Site Audit Report

No Scrape Area South, Former Schofields Aerodrome, Triton Parade,
Nirimba Fields NSW 2763

Audit Number: MP169_05_R1

5 September 2023

Figure 3: Post Round 1 Excavation Validation Sampling Locations and Exceedances

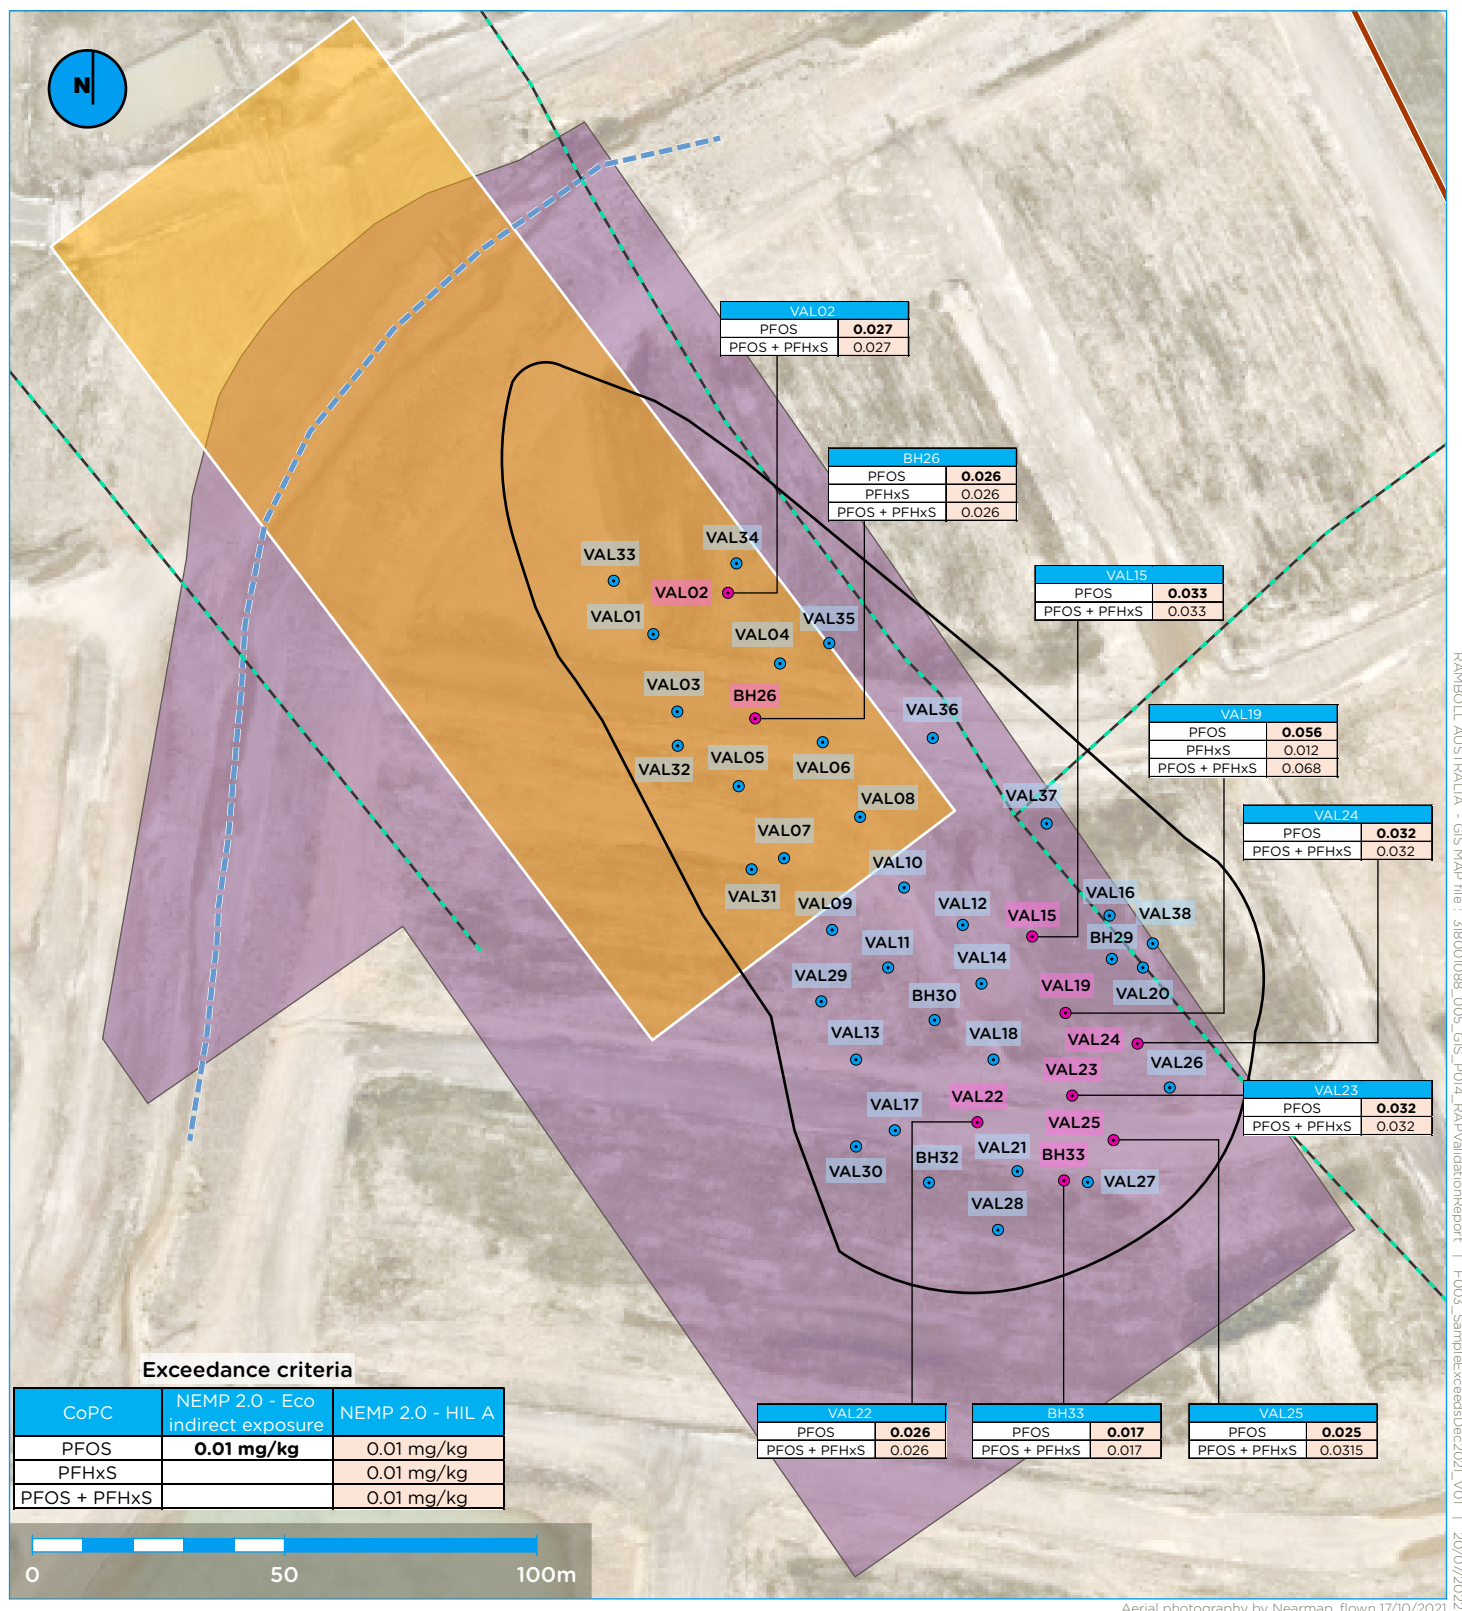
8. **Site Preparation:** Please clarify what is the 'sediment placement area' shown in Figure 3 (Appendix 1).

9. **Remediation Extent (Figure 3 Appendix 1):** Ramboll indicated that the initial remediation/excavation extent is selected as halfway to the nearest location that meets the validation criteria. Please check as this does not appear to be case between BH32 and BH31; BH33 and BH34; and BH29 and BH34..

- The legend for Figure 1, 2 and 3 indicated that the validation area is 'north of swale "no scrape" area'. Please amend this to 'No Scrape Area South' to avoid confusion.
- Figure 3 indicated 18 µg/kg PFOS and Sum PFOS + PFHxS reported for NS_BH29_4.1. This is inconsistent with the concentrations shown in Table 1 for this sample.
- Adopting the conservative approach whereby the highest concentrations measured amongst the primary and duplicate samples are shown in Figure 3:
 - The results for NS_BH35_4.0 should be the highest concentrations measured at QC20 (split duplicate sample).
 - The sum of PFOS and PFHxS result for MW_BH36_4.7 should be the highest concentration measured at QC26 (split duplicate sample).

Figure 12: No Scrape South Cut/Fill Plan

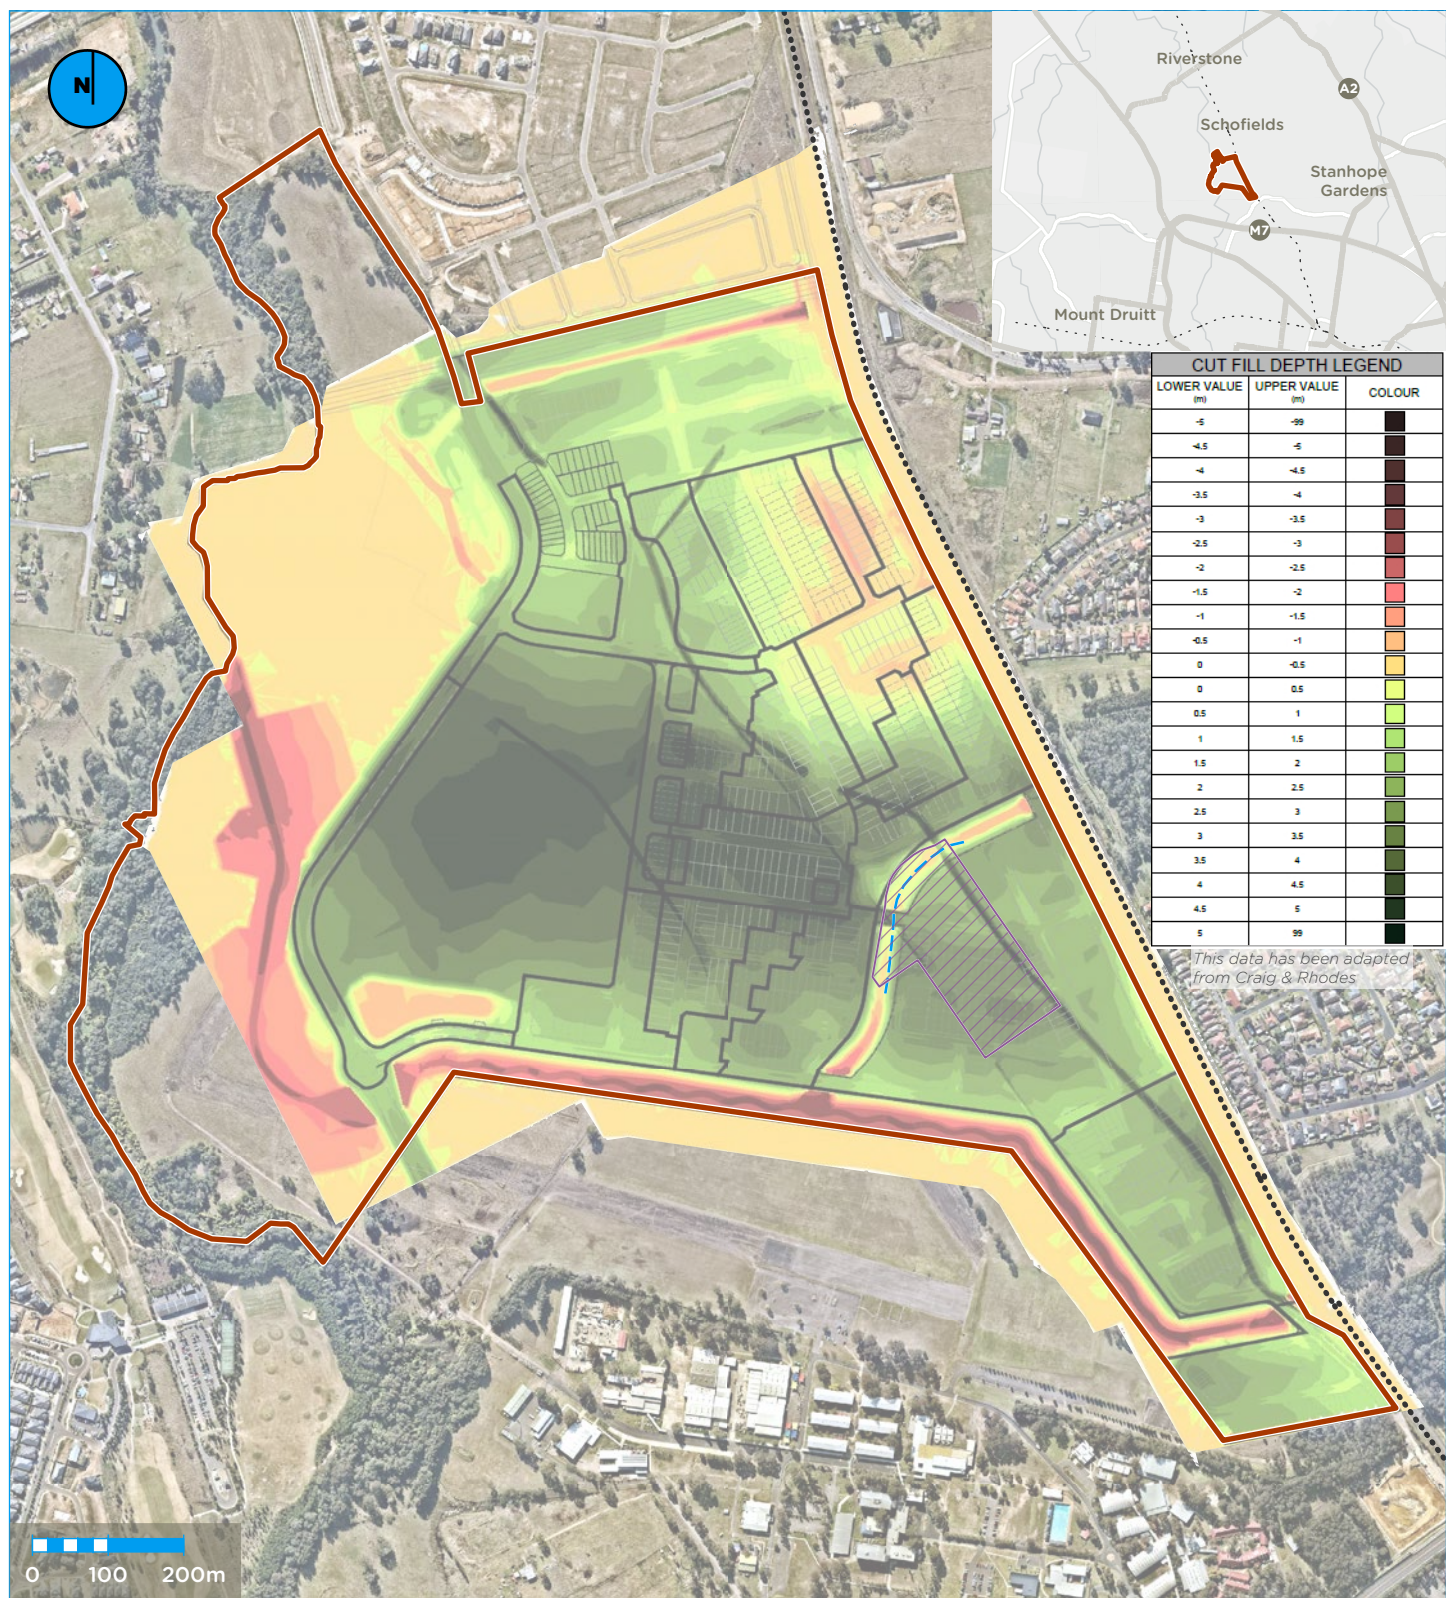
- 25. Figure 12:** The heat map/cut and fill depth legend colours are not legible in the No Scrape Area South due to the purple solid colour infill. Please amend so that only the outline of No Scrape Area South is shown; and remove PFAS MEA, former drainage channel and FFTA as they are not relevant to the figure.

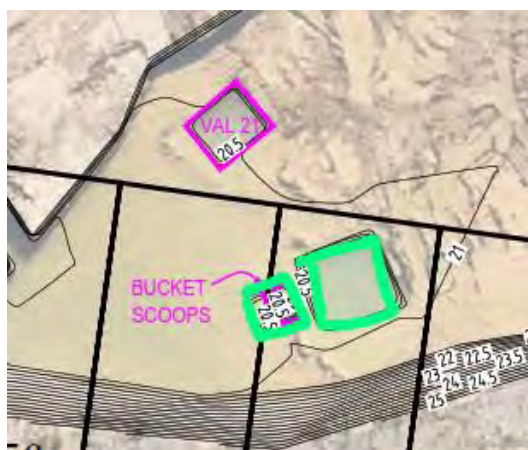
9. Section 6.1.2, Excavation Surfaces Validation: There appears to be two excavations south-southeast of VAL21 shown in Craig & Rhodes plans provided as Appendix L (marked with green in screenshot below). Please clarify what are they are they are not shown in Figure 6 to 8 or discussed in Section 6.1.2.
